**TOWNSHIP OF ABINGTON**  
**PLANNING COMMISSION**

**May 26, 2020**

**SUBJECT: JSF MANAGEMENT, LLC-1538 & 1546 EASTON RD  
PRELIMINARY/FINAL LAND DEVELOPMENT PLAN REVIEW NO. 3  
ABINGTON TOWNSHIP, MONTGOMERY COUNTY, PENNSYLVANIA  
PROJECT NO. 1926018R**

Re: MCPC #19-0302-001  
Plan Name: Self-Storage Facility  
1 lot on 1.02 acre  
Situate: 1538-1548 Easton Rd. (cross street: Hamilton Ave.)  
Abington Township

Attachment A: Reduced Copy of Applicant's Subdivision and Land Development Plan

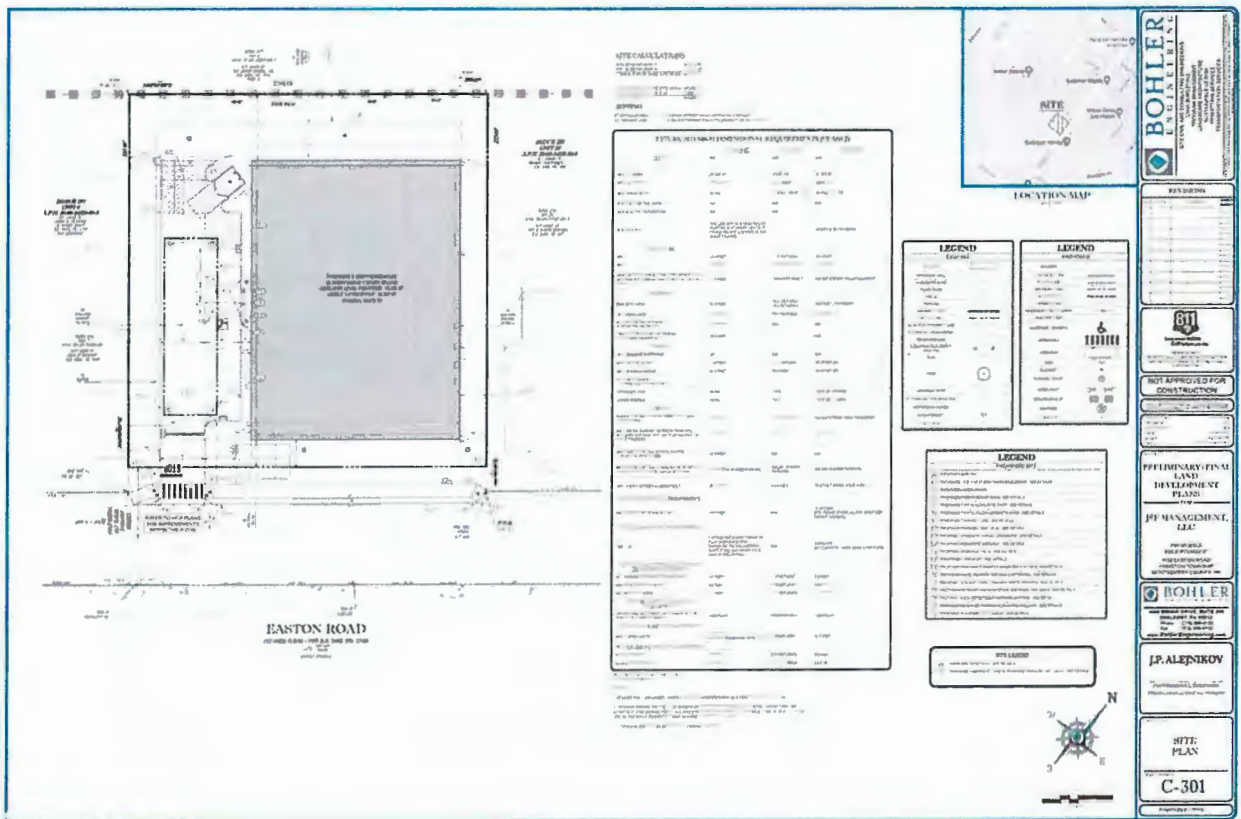
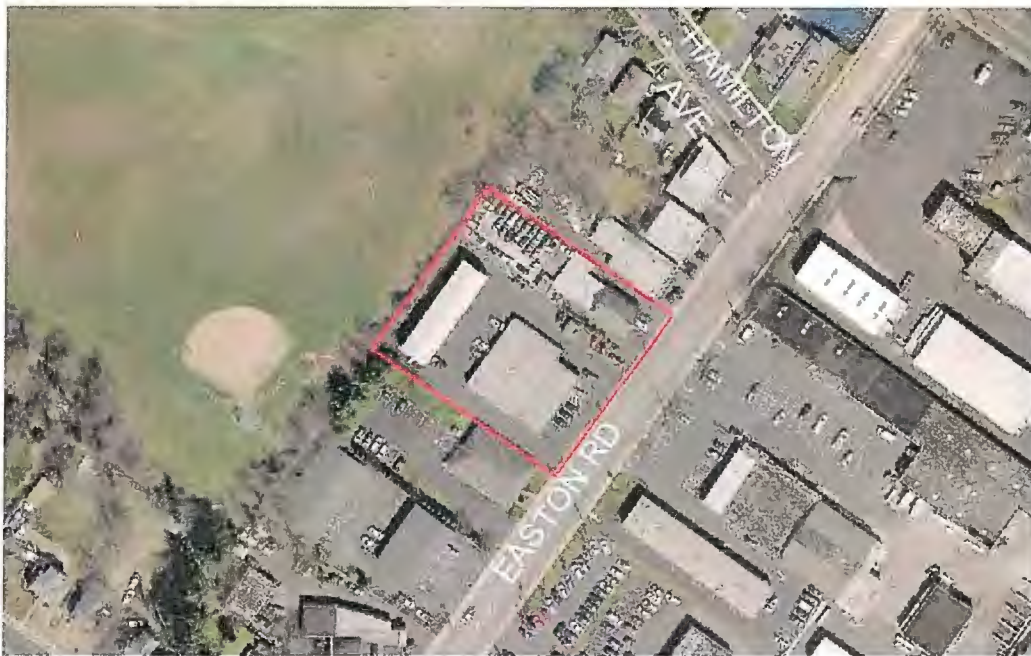
- A. Lot Consolidation Plan – It is not clear where the boundaries are of the existing lots being combined; the applicant proposes combining two properties, but three are shown on the Lot Consolidation Plan.
- B. Tax parcel numbers shall be provided on the property identification [§146-11].
